LAS CAMAS SOLAR PROJECT

FINAL SUBSEQUENT ENVIRONMENTAL IMPACT REPORT

November 2024

Revised March 2025

Figure 2-1: PV Panel Reflection Angle Illustration. Reflectance depends on incidence angle between panel normal (i.e. facing) and sun position. Large incidence angle yields more reflected sunlight (ForgeSolar. 2024).

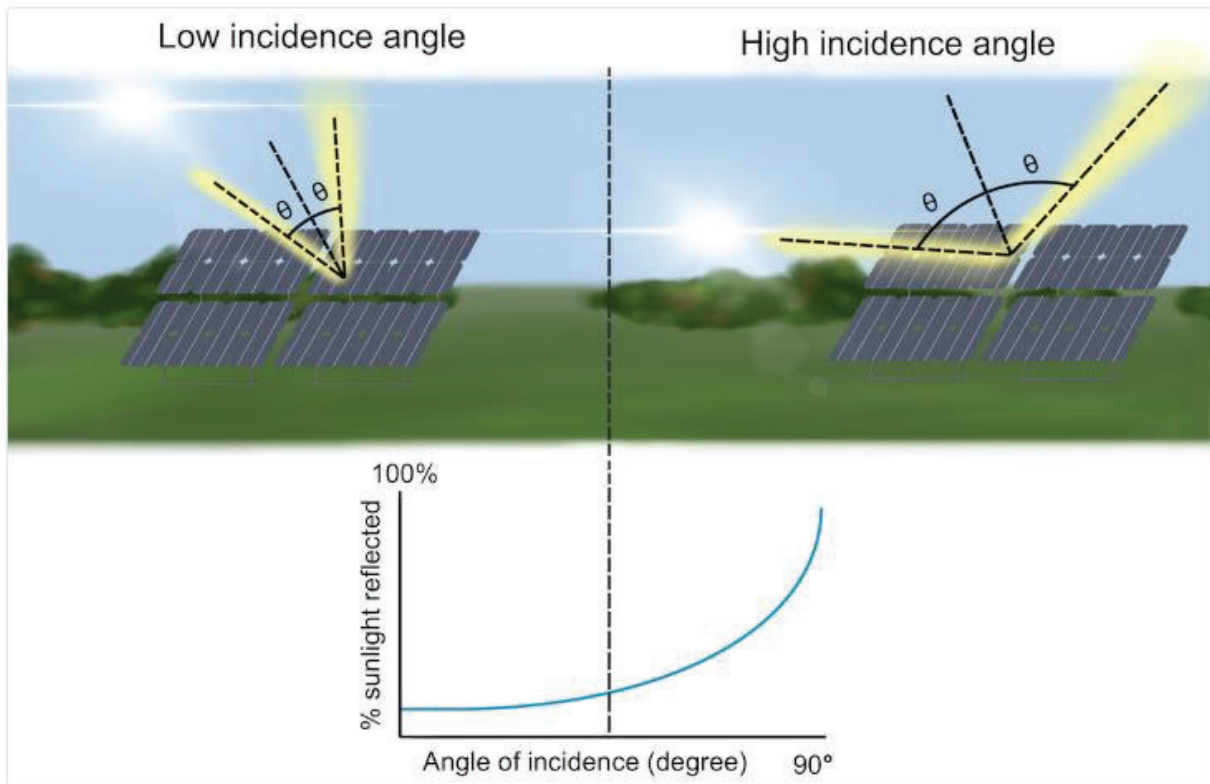
The commenter expresses concern over having what he terms mirrors pointing toward his property and the destruction of views due to the topography and implementation of the project. APNs 078-190-010 and 078-190-009 border the solar project site on the south.

As described in Section 3.1, *Aesthetics*, and shown in Figures 3.1-3 through 3.1-4, the project would not use mirrors, but instead would use darkly colored photovoltaic panels that would tilt and be oriented to face east-west. Therefore, the panels would not be directly angled toward the commenter's property, which is located south of the solar project site in a relatively flat area. As described under Impact AES-4, which has been revised for better clarity in Chapter 3, *Draft SEIR Errata*, "...When the sun is high in the sky (close to noon or in the summer) and the panel is low to the ground, any reflection would be upward toward the light source and back into the atmosphere away from terrestrial-based receptors. When the sun is low on the horizon (near dawn or dusk or in the winter), the sun's angle in the sky is low; reflected rays would still be directed away from terrestrial-based receptors because the maximum downward angle of the arrays would not be below 30 degrees." Figure 2-1, below, is a graphic that helps illustrate the concepts of what a reflection angle looks like when the sun is high in the sky or low on the horizon.

There is also a 237-foot distance from the southern edge of where the panels would begin on the solar site, as shown in Draft SEIR Figure 2-2, and the commenter's property boundary. Therefore, due to panel orientation and the offset for where the panels begin, the surfaces of the solar panels would not point towards the commenter's property, even with the topography of the site. In addition, Impact AES-3 evaluated operational impacts under *Changes in Proposed Land Uses and Development from the Community Plan* starting on page 3.1-32 and under *Additional Proposed Development Outside of the Community Plan* starting on page 3.1-35 of the Draft SEIR, which evaluated the light and glare impacts. This analysis identified that the panels would be darkly colored, to absorb sunlight, and would receive an anti-reflective coating. The panels would not have the appearance of mirrors. The Draft SEIR found that no new or substantially more severe significant impacts would result beyond those identified in the previous EIR and no additional mitigation would be required.
